Access Compliance Report

Public Rights-of-Way

(Curb Ramps)

Intersection ID: 2952	Main Street: CREEK_BREEZE_RD	Cross Street: GREEN_PASTURE_RD	Location: W
ADA ID: 581A6E9687A0	Ramp Type: PerpDiag	Initial Pass/Fail: Fail	Overall Compliance: No
Severity Score: 1.25			
Codes/Mitigation Info/Possible Solution		Field Measurements/Component Compliance

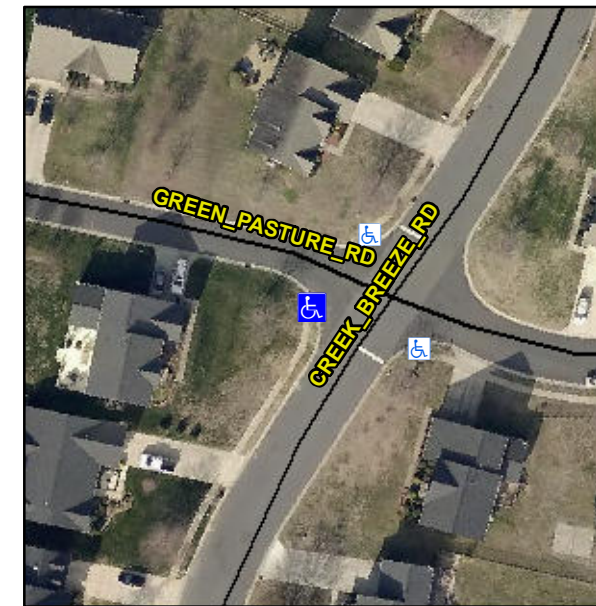
Not Found, R304.5.3

Compliance	Description	Data	Compliance	Description	Data
N/A	Ramp Length (in)	43.0	Yes	Ramp Slope (%)	7.7
Yes	Ramp Width (in)	59.0	No	Ramp XSlope (%)	3.1
N/A	Flare Type LT	N/A	N/A	Flare Type RT	N/A
N/A	Flare Slope LT (%)	N/A	N/A	Flare Slope RT (%)	N/A
N/A	Flare Traversable LT?	N/A	N/A	Flare Traversable RT?	N/A
N/A	Landing Length (in)	N/A	N/A	DWS Provided?	N/A
N/A	Landing Width (in)	N/A	N/A	DWS Contrast?	N/A
N/A	Landing Slope (%)	N/A	N/A	DWS Length (in)	N/A
N/A	Landing X Slope (%)	N/A	N/A	DWS Full Width?	N/A
N/A	Landing Curb? (Y/N)	N/A	N/A	DWS Offset (in)	N/A
N/A	Shared Landing?	N/A			
N/A	Gutter Ponding?	N/A	N/A	Gutter Slope (%)	N/A
N/A	Gutter Lip Ht (in)	N/A	N/A	Gutter X Slope (%)	N/A
N/A	Painted X Walk1?	No	N/A	Painted X Walk2?	No
	X Walk 1 Direction	To SE		X Walk 2 Direction	To NE
N/A	X Walk 1 Width (in)	N/A	N/A	X Walk 2 Width (in)	N/A
	X Walk 1 Slope (%)	0.2		X Walk 2 Slope (%)	1.8
	X Walk 1 X Slope (%)	3.4		X Walk 2 X Slope (%)	4.5

Remove & Replace Curb Ramp With Two New Directional Ramps or Equivalent.
